MEMORANDUM

SUBJECT: SP-18-002 – The Retreat at Timber Ridge
Fourth Submittal
CCES Drainage Responses – South Report (Red)

THE RETREAT AT TIMBERIDGE PRELIMINARY DRAINAGE REPORT (SOUTH OF ARROYA LANE) PRE-DEVELOPMENT DRAINAGE MAP

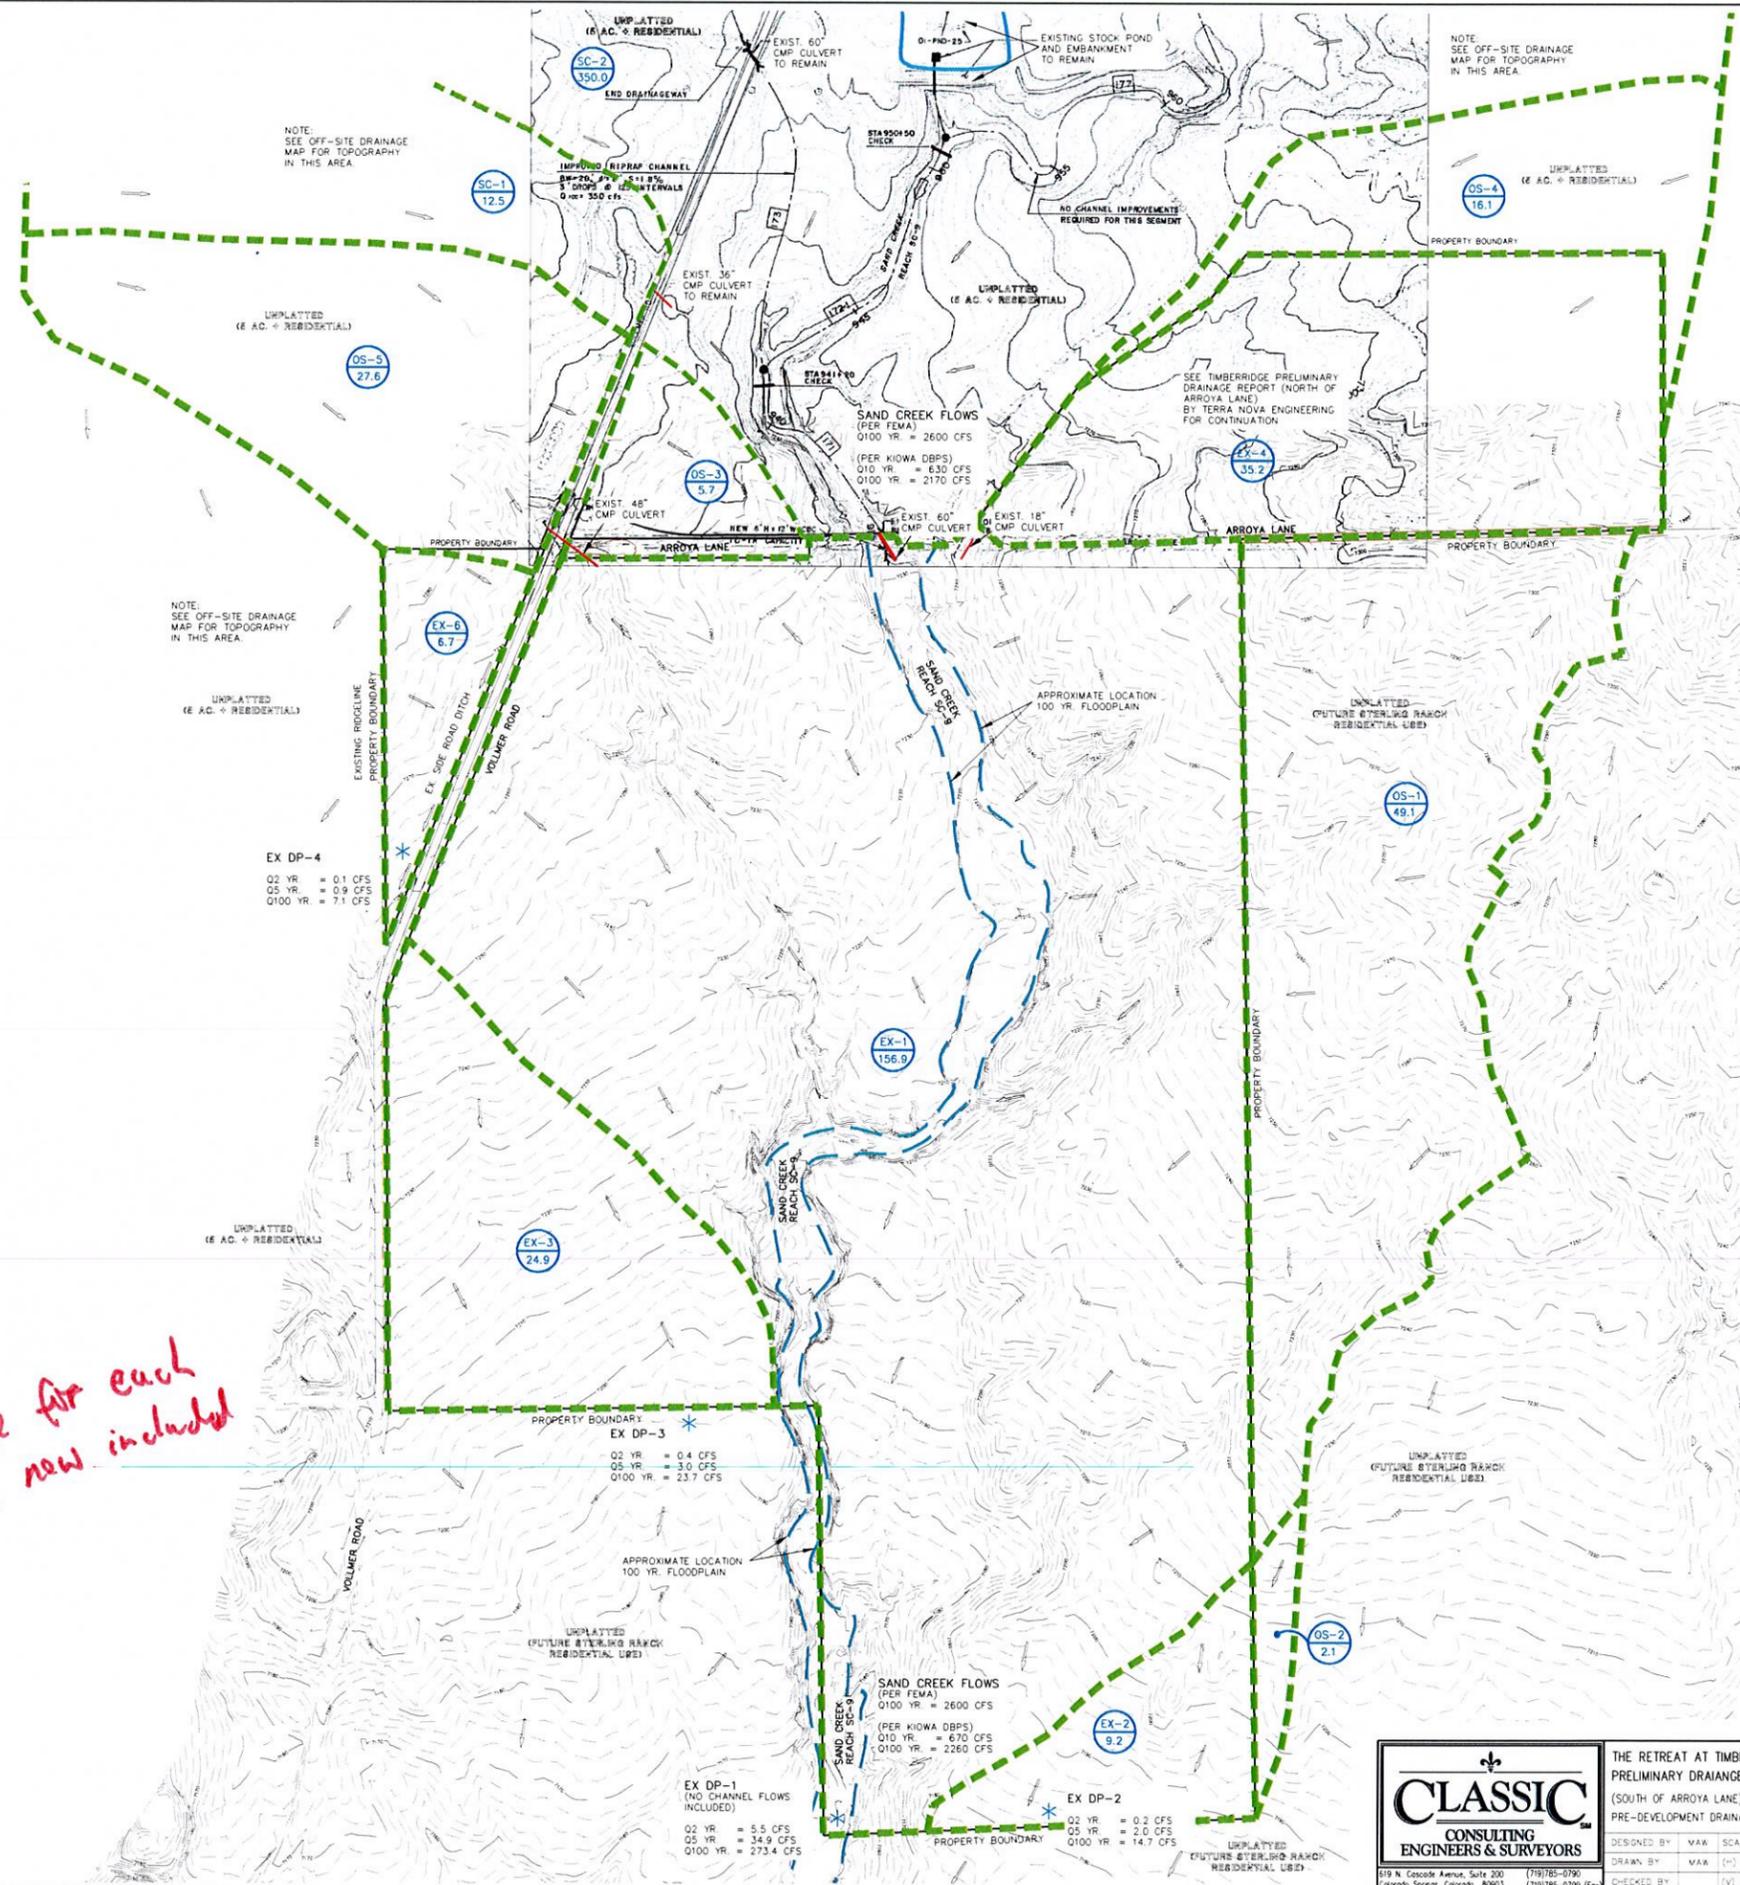
Delete?

Provide column with design point contributing area

Acresage for each D.P. now included
